M-TIPS

2004 RX-8

Grease Oozing From Audio Switch

**Grease Will Be Noticeable
In This Area**

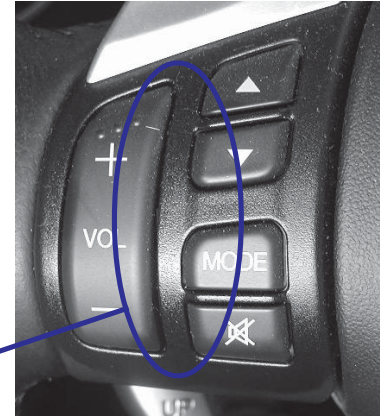
On some vehicles, grease may ooze from the steering wheel mounted audio control switches. The cause of this concern is an excessive amount of grease applied at time of manufacture. This has resulted in a mass production change and the audio control switch has been modified.

- The specified amount of grease applied to the switch during assembly has been decreased.
- The switch button panel finish has been changed to a smooth polished texture.

Customers with this concern should have their vehicles inspected and repaired as necessary. Replace defective switch with a modified one. Refer to Workshop Manual section 09-20-17 AUDIO CONTROL SWITCH REMOVAL/INSTALLATION.
